TOWN OF NISKAYUNA
Planning Board and Zoning Commission
Agenda
April 11, 2022
7:00 PM

AGENDA STATEMENT

ITEM TITLE: DISCUSSION: 3713 State Street – Goodyear Tire Store – site plan application for placement of a 20' long x 8' wide storage container on the property

ITEM TITLE: DISCUSSION: 2341 Nott St. – St. James Plaza – site plan application for placement of a Chase Bank ATM in a portion of the Shop Rite parking lot.

3713 STATE ST. - GOOD YEAR

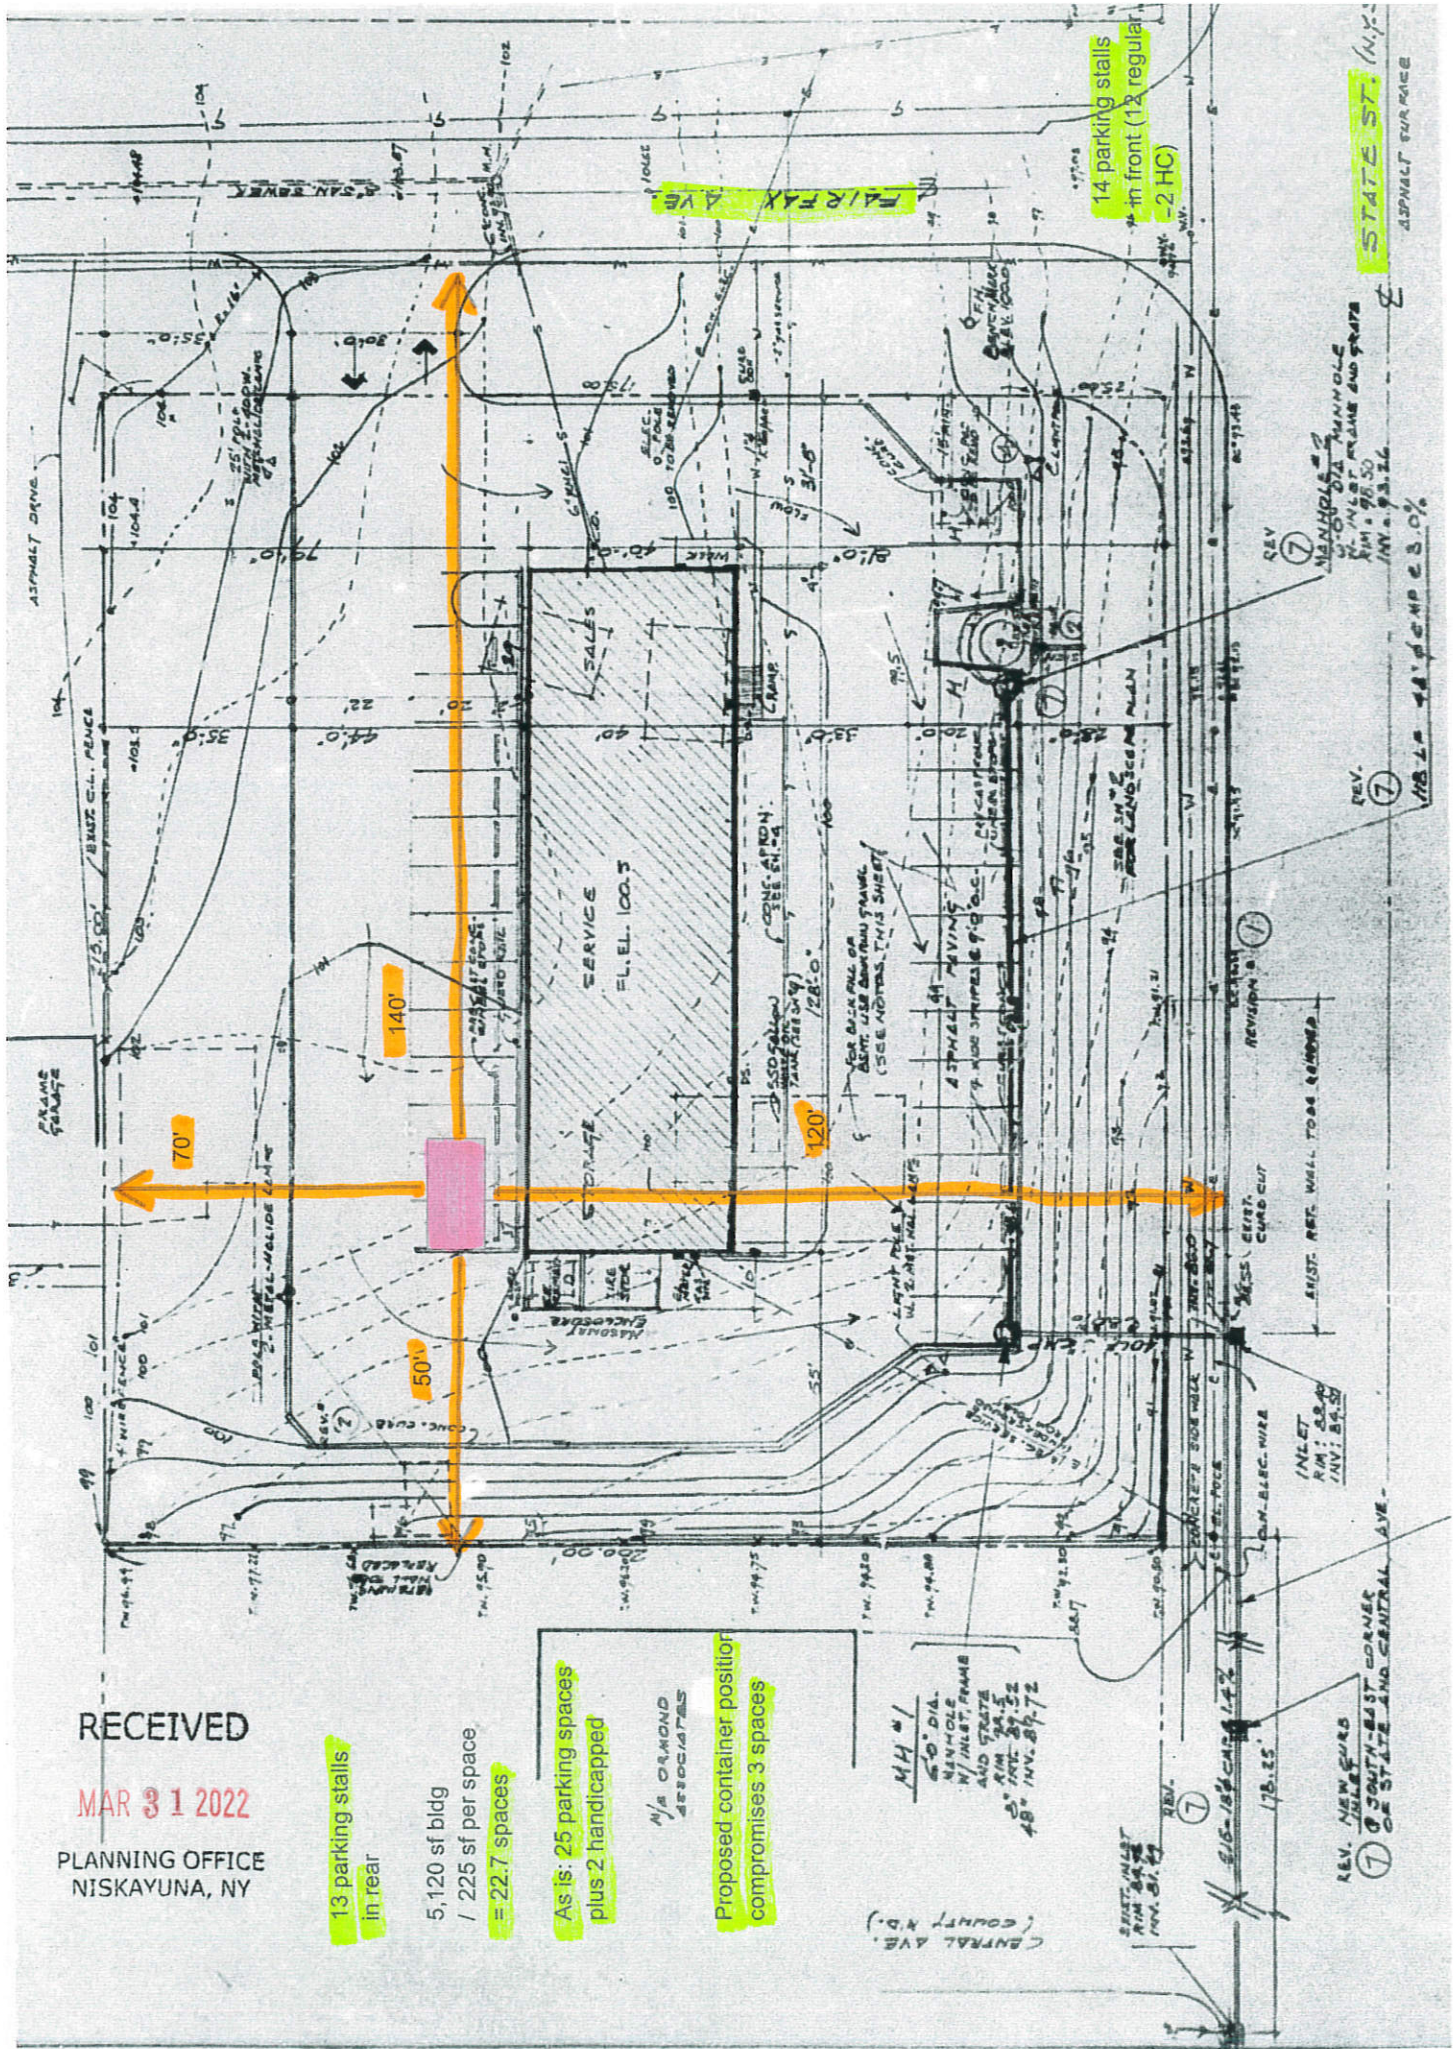
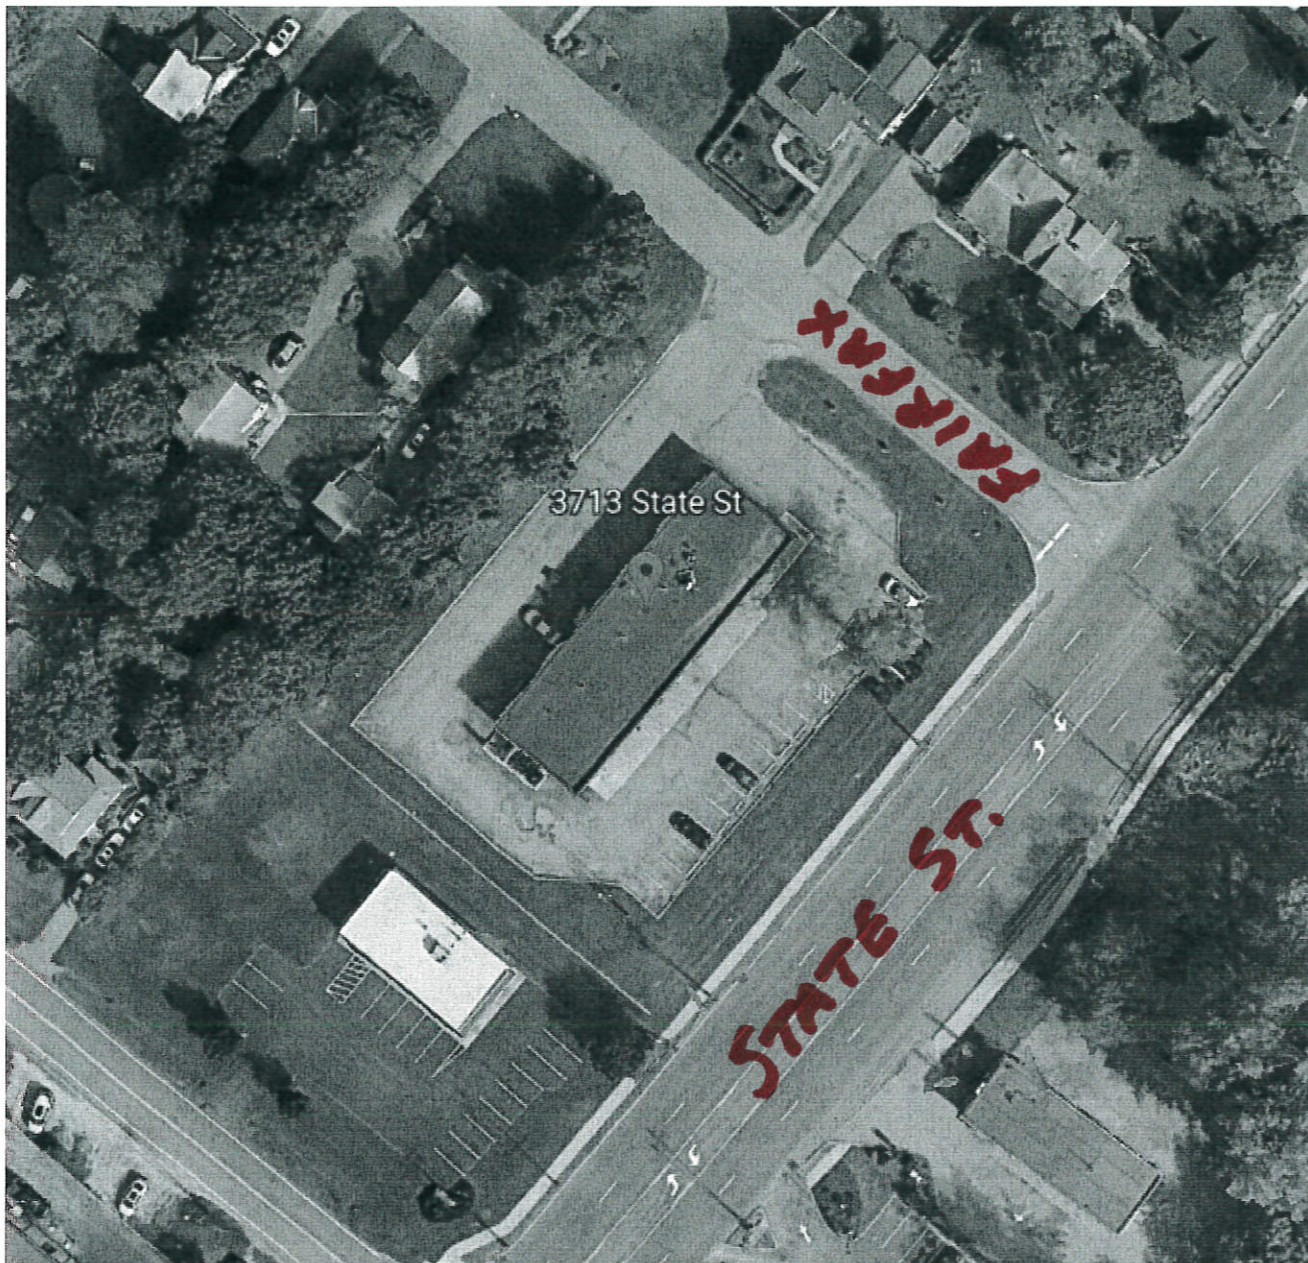
As proposed, the site plan drawing provided with the application lists the setback dimensions as follows: front (to Fairfax Ave.) = 140’, side = 70’, rear = 50’ and are therefore compliant with code. The drawing also indicates the container would be approximately 6’ from the existing building.

The site plan drawing provided with the application indicates the building measures 128’ wide x 40’ deep = 5,120 sq. ft. A retail store of such size requires 23 parking spaces ($5,120 / 225 = 22.76 = 23$ spaces). The site plan drawing provided with the application identifies a current condition of 25 parking spaces plus 2 handicap accessible parking spaces. As proposed, the storage container would occupy 3 of the current parking spaces resulting in 22 parking spaces plus 2 handicap accessible parking spaces.

Proposed container position
 comprises 3 spaces
